Addendum No.1 (RFI Response)

Project	Bucks County Library, Doylestown TR Improvements	Response Author	Stephen G. Custer
RHJ Project ID	2018-0131	Response Date	09/20/2018
RFI ID	Addendum No.1		
Submitted By	Kristi Engler		
Received On	09/18/2018

PROPOSED IMPROVEMENTS FOR:
BUCKS COUNTY LIBRARY
 DOYLESTOWN BRANCH
 150 SOUTH PINE STREET
 DOYLESTOWN, BUCKS COUNTY, PENNSYLVANIA

1) FLOOR PLAN

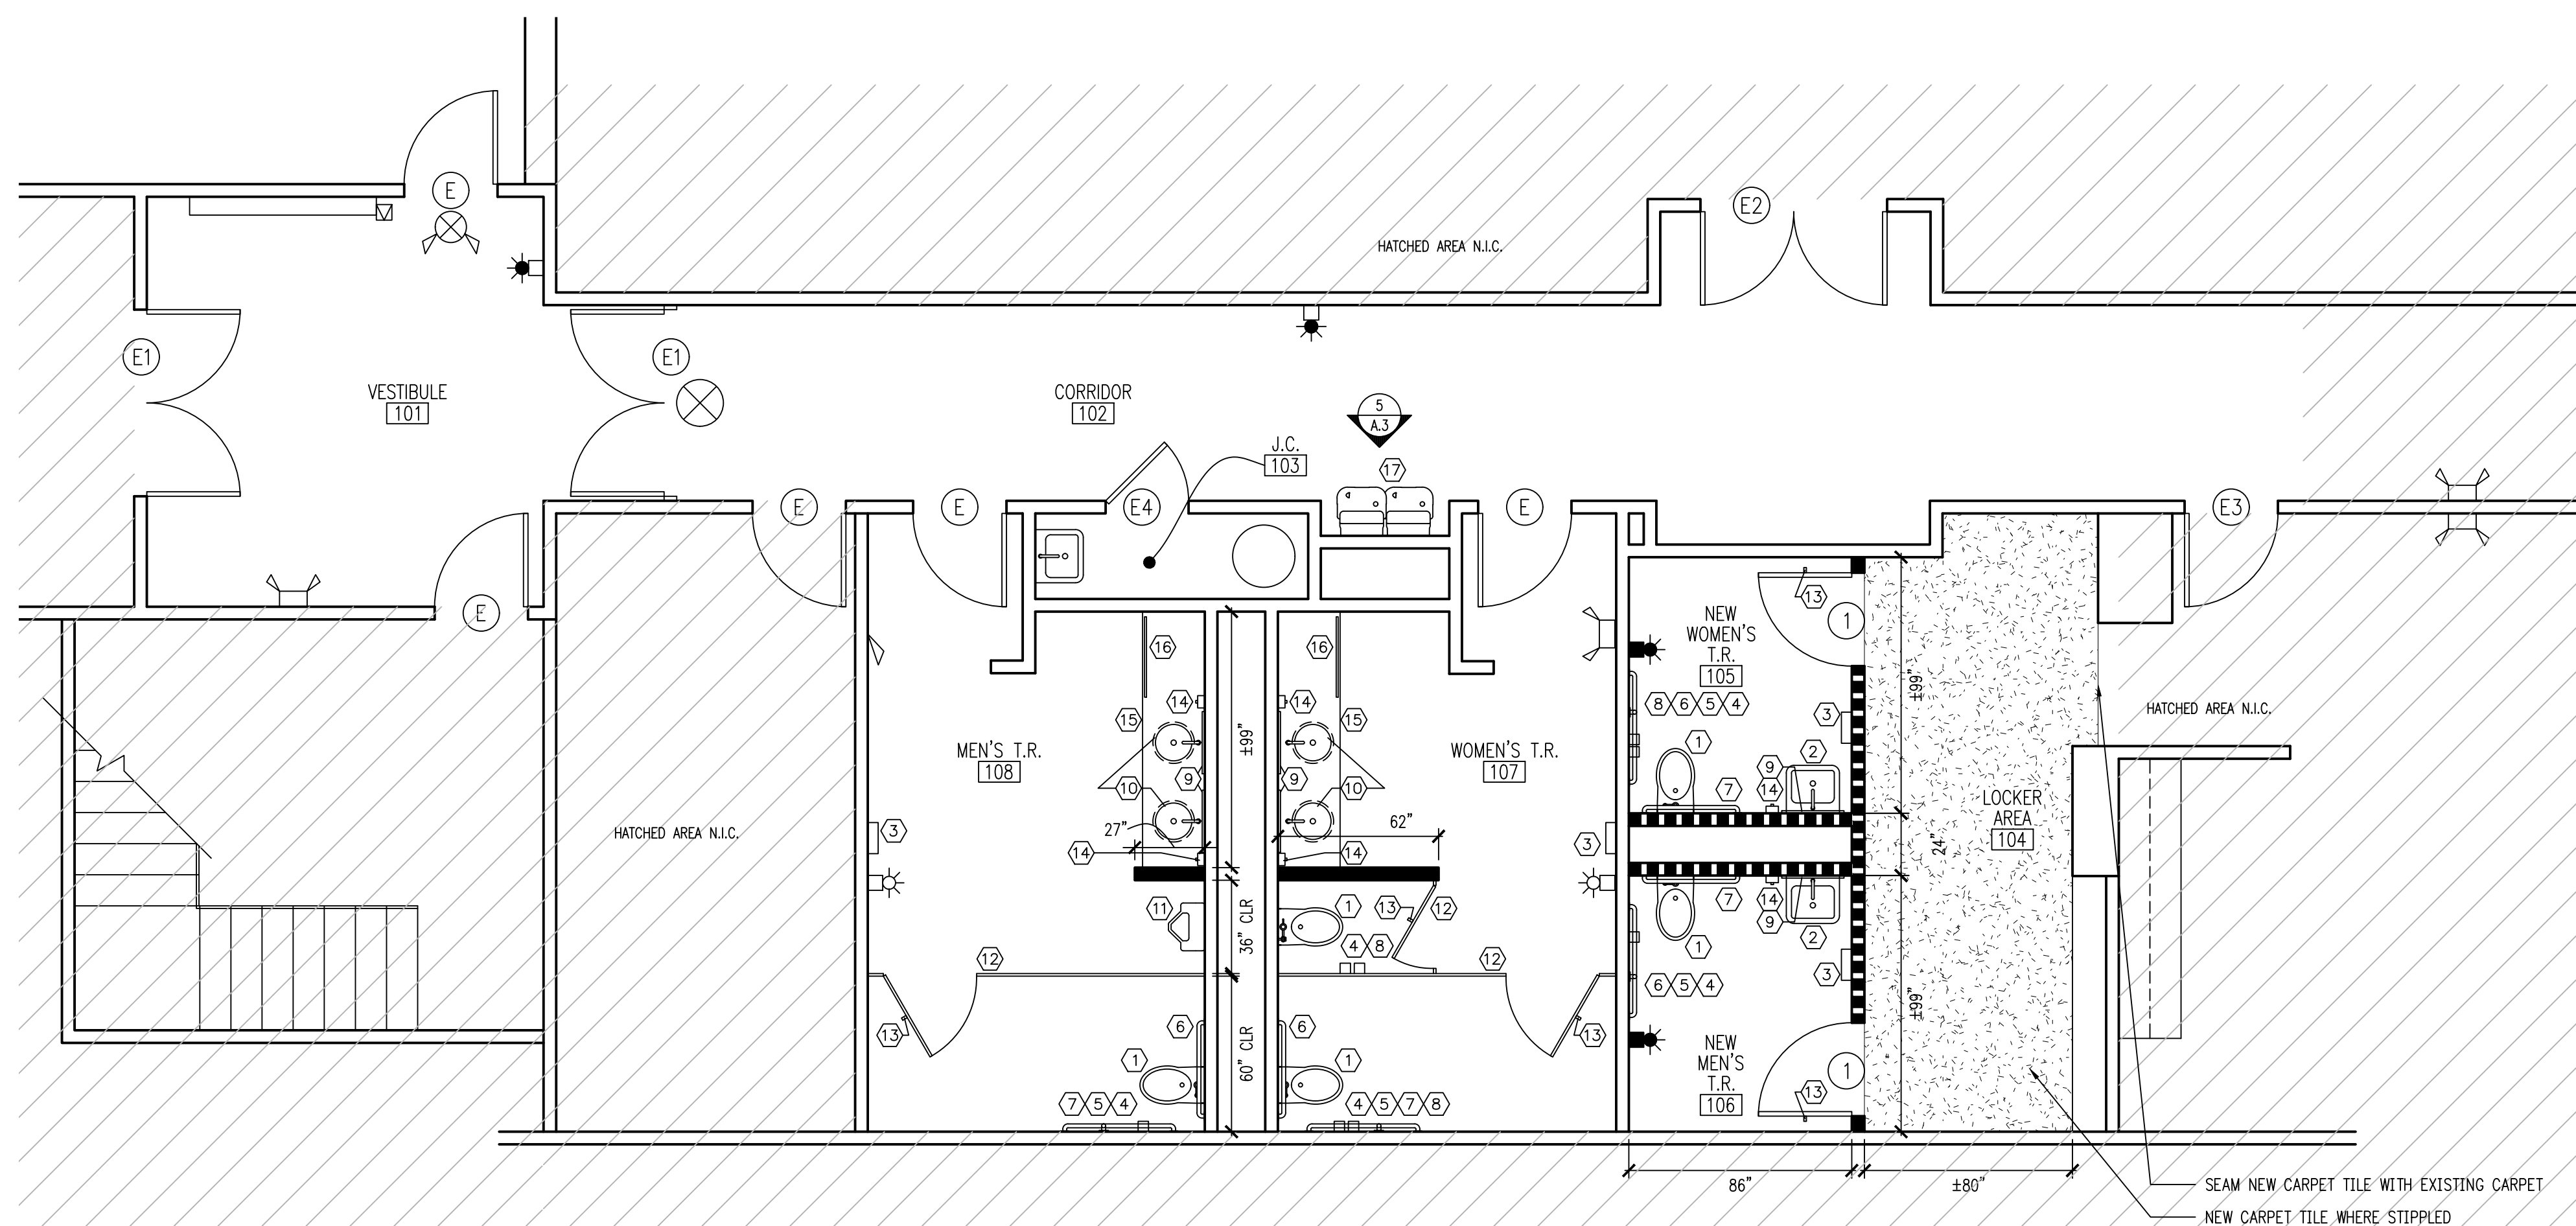
The door schedule calls for new hardware sets E1, E2, E3, and E4. All of these except E4 appear to be out of the area included in the scope of work. Are we to install this new hardware? If so, could you please give me the contact of your security contractor as they will most likely need to install this hardware.

All of the doors referenced in the question above are to receive new hardware as scheduled on sheet A.2, installed by the G.C. The hatched area indicating Not in Contract has been updated, clarifying that these doors are to be included in this scope of work. A revised A.1 sheet dated 2018/09/20 that shows the hatching change is included. The owner's security contractor is Fortress Protection, LLC - 856-424-3000 or 215-854-8400.
